104 Mary Street, Richmond 3121

APPLICATION NO: PLN18/0224

DESCRIPTION: Development of the land for construction of three, double-storey dwellings

COMMENTS SUMMARY

Idle Architecture Studio Drawing No.TP 2.01 and TP2.02 Revision C dated 30 January 2019

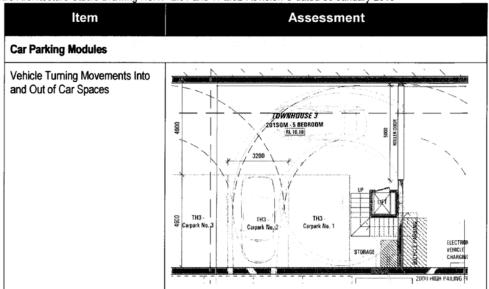
Item	Assessment			
Access Arrangements				
Development Entrance	Access to the development's basement car park is off Mary Street and the entrance has a width of 3.6 metres to satisfy <i>Design standard 1 – Accessways</i> .			
Car Parking Modules				
Car Spaces	The 3.2 metre by 4.9 metre car spaces satisfies <i>Table 2</i> of <i>Design standard 2 – Car parking spaces</i> .			
Aisles	A minimum aisle width of 4.8 metres has been provided to satisfy <i>Table 2: Minimum dimensions of car parking spaces and accessways</i> of Clause 52.06.			
Vehicle Turning Movements Into and Out of Car Spaces	Swept path diagrams for a B85 design vehicle has not been provided. Using Trapeze, the turning movements into and out of the car spaces for a B85 design vehicle are considered satisfactory, as shown in the diagram below.
